XLamp® XP-C LED Product Change Notification

Customer Name: XPC White, Blue LED Customers PCN Reference Number: CreeLED-PCN-5313
Date Issued: May 16, 2022

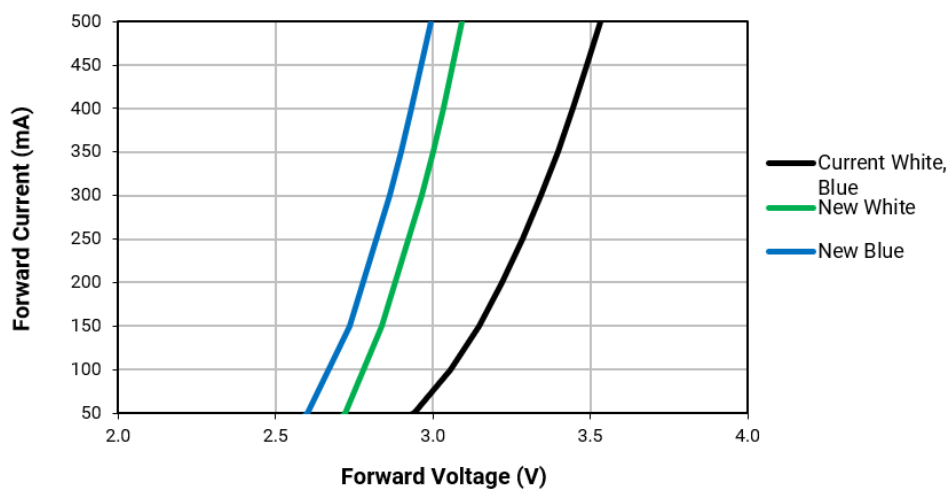
Cree LED will be changing the typical thermal resistance, typical and maximum forward voltage, and typical temperature coefficient of voltage characteristics for the affected XP-C LEDs. Table 2 shows the current and new values.

The following graph shows the improved Forward Voltage vs Current curves.

Figure 1 XP-C White Appearance Comparison

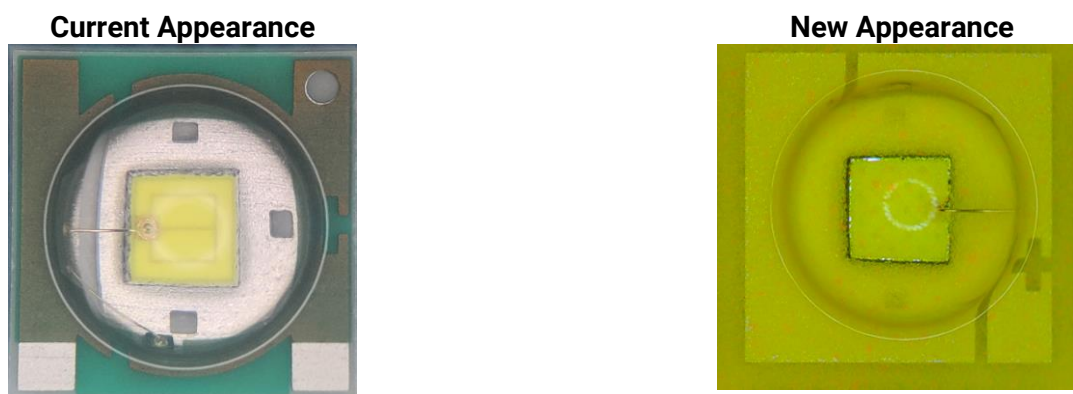
The visual appearance of the LED will change. Examples of the current and new visual appearances are shown below.
